**PUD &
SUBDIVISION STAFF REPORT**
6, 2004

Date: May

Ravin 2 Subdivision

SITE PLAN

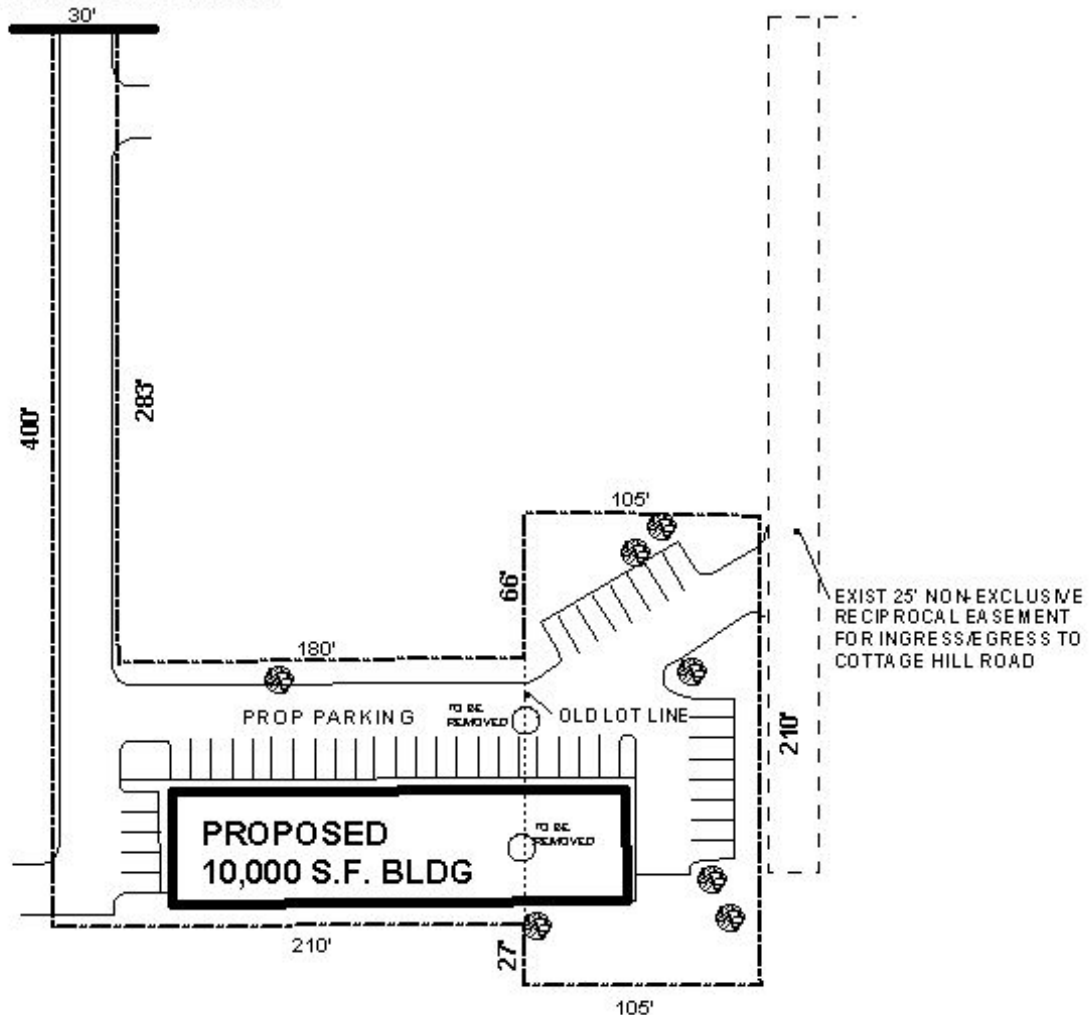
One concern relating to the site plan is that the proposed development may require the removal of numerous trees that were claimed for credit as part of the Rite Aid (formerly K&B) development adjacent to the East. The Urban Forester has met with the engineer and informed him of what would be required to permit the removal of those trees.

Another concern is the potential location of signage, both at Cottage Hill Road and Hillcrest Road. While no signage was indicated on the plan, it is obvious that there is no room for the construction of a free-standing sign along the Cottage Hill Road frontage, and the site does not have frontage on Hillcrest Road (access to Hillcrest Road is available through the shared drive to the West, but is not a part of the site). Therefore, the applicant should be advised that an off-premise sign is not allowed.

The plan indicates an existing 6' wooden privacy fence along the South property line, where the site abuts residential property. This fence appears to be located on the residential property.

While the Zoning Ordinance requires that the commercial property provide the buffer protection between residential and commercial properties, it would not be logical for this development to erect a 6' privacy fence immediately adjacent to a 6' privacy fence. Therefore, as a condition of approval the developer should be required to maintain the existing fence, or if the existing fence should ever fall into a state of disrepair, the

commercial property would be required to install a fence on the commercial property at that time.

Planned Unit Development: Based on the preceding, it is recommended that the application to allow shared access between multiple building sites with multiple buildings be approved subject to the following conditions: 1) completion of the subdivision process; 2) removal of trees formerly claimed for credit as part of the Rite Aid (formerly K&B) development adjacent to the East to be coordinated with / permitted by the Urban Forester; 3) prior to permitting the removal of any trees, the Urban Forester to ensure that the Rite Aid (formerly K&B) site adjacent to the East is in full compliance with the tree planting requirements; 4) the existing fence along the South property line to remain, but if it ever falls into a state of disrepair, the commercial property shall immediately install a 6' privacy fence; and 5) full compliance with all municipal codes and ordinances.

Subdivision: With minor modifications, the plat will meet the minimum requirements of the Subdivision Regulations and is recommended for Tentative Approval subject to the following conditions: 1) placement of the required setback on the final plat; and 2) the placement of a note on the final plat stating that if the existing privacy fence along the South property line should fall into a state of disrepair, a buffer in compliance with Section V.A.7. of the Subdivision Regulations, will be provided.
